Region 10 Enforcement and Compliance Assurance Division
1200 6th Avenue
Seattle, WA 98101
INSPECTION REPORT

Inspection Date:	02/23/2021	
Time:	Entry: 10:30 a.m.	Exit: 12:00 p.m.
Media:	Water	
Regulatory Program:	CWA NPDES/Construction Stormwater	
Operator Name(s):	M3 ID Falcon Crest, LLC– (Notice of Intent IDR1002CN)	
Operator Addresses:	1087 W. River St., Ste. 310	
Operator City, State, Zip Code:	Boise, Idaho 83702	
Site Name:	Falcon Crest Subdivision	
Site Physical Location:	Approximately 10 miles southwest of Boise, Idaho, Kuna Road & South Cloverdale Road, City of Kuna, Idaho	
	Latitude/Longitude	43.4932°N, 116.3306°W
City, State, Zip Code:	Kuna, Idaho, 83634	
Site Contact(s):	Mark Tate, Project Manager Phone: (208) 631-2025 Email: MTate@M3Companies.com	M3 ID Falcon Crest, LLC
County:	Ada County, Idaho	
Site Identifier:	Falcon Crest Subdivision	
Estimated Site Area to be Disturbed:	128.25 acres	
Site Receiving Water(s)	Unnamed Intermittent Stream, New York Canal	
Site Receiving Water(s) Description:	Irrigation canal and canal

Exhibit 2. Image of the Site map provided on Site of the Falcon Crest Subdivision. It was noted the Site map does not include all the locations where stockpiles, drainage patterns, or perimeter controls were located. Note the wet pond.

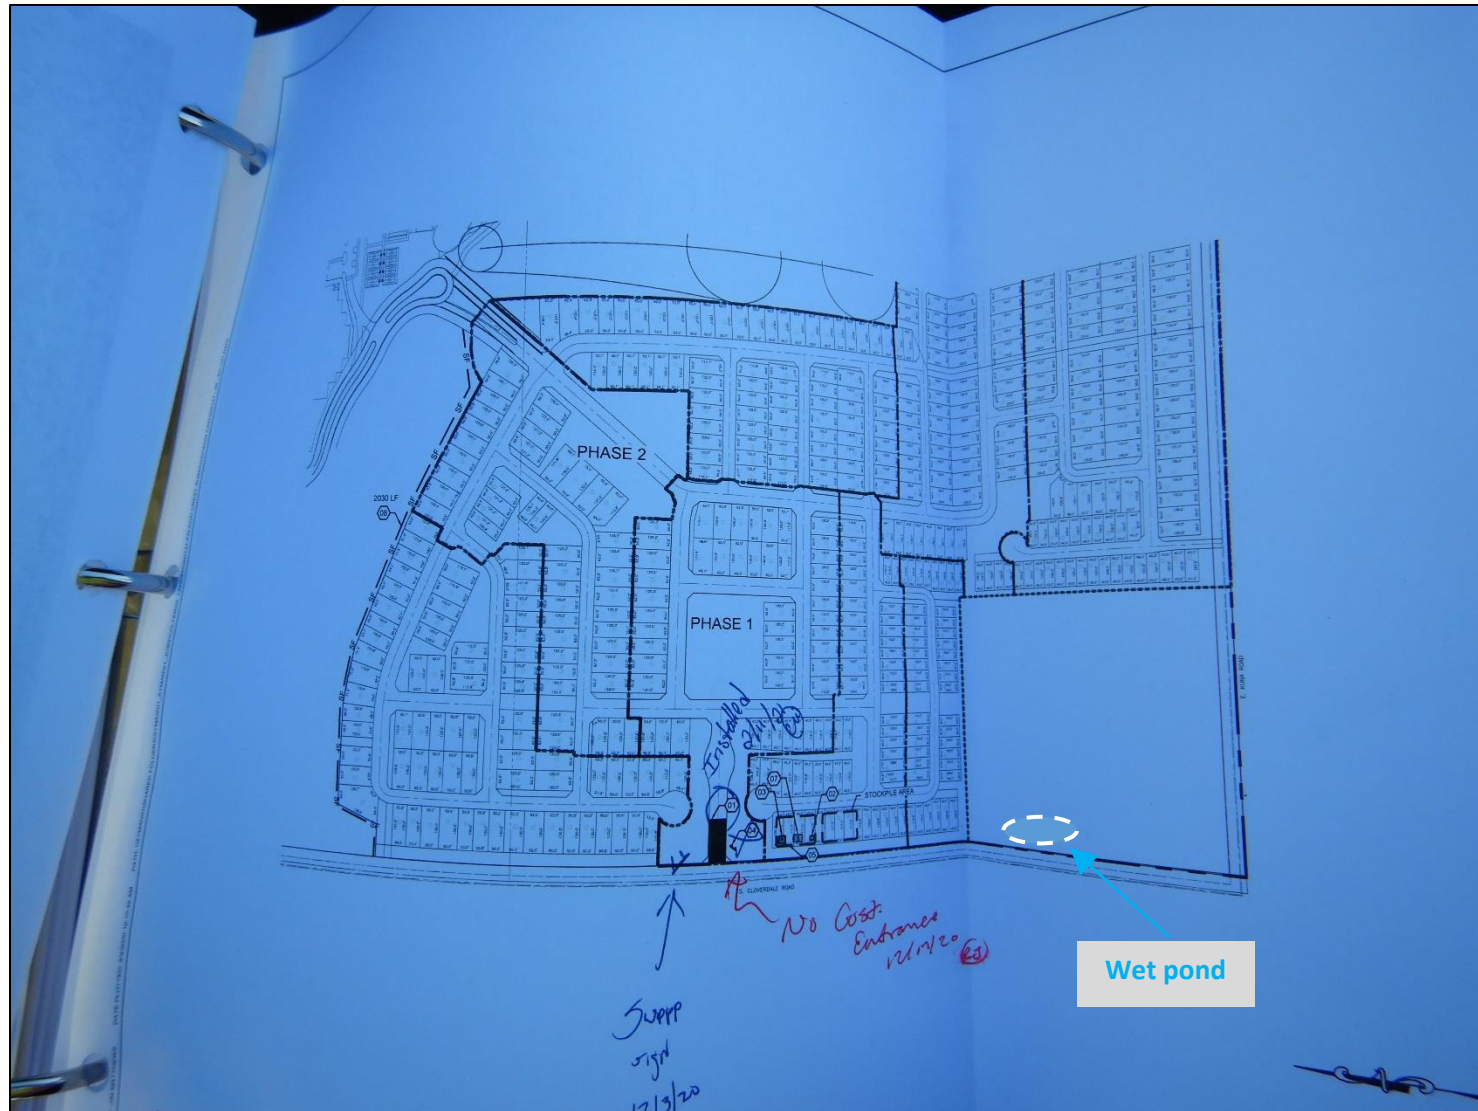
We observed that the SWPPP map presented onsite did not identify a soil stockpile located at the center of the Site in Phase 1. The SWPPP map designated a stockpile area, however, the stockpile was not located in that area (refer to Attachment A, Photograph 2, and Attachment B, Exhibit 2).

We also observed that the SWPPP map did not contain drainage patterns of stormwater and authorized non-stormwater before and after major grading activities as required by part 7.2.4.f of the Permit.

Additionally, we observed a perimeter control of a vegetated buffer along the western perimeter of the Site that was not labeled on the SWPPP map as required by part 7.2.4.i of the Permit (refer to Attachment A, Photograph 3).
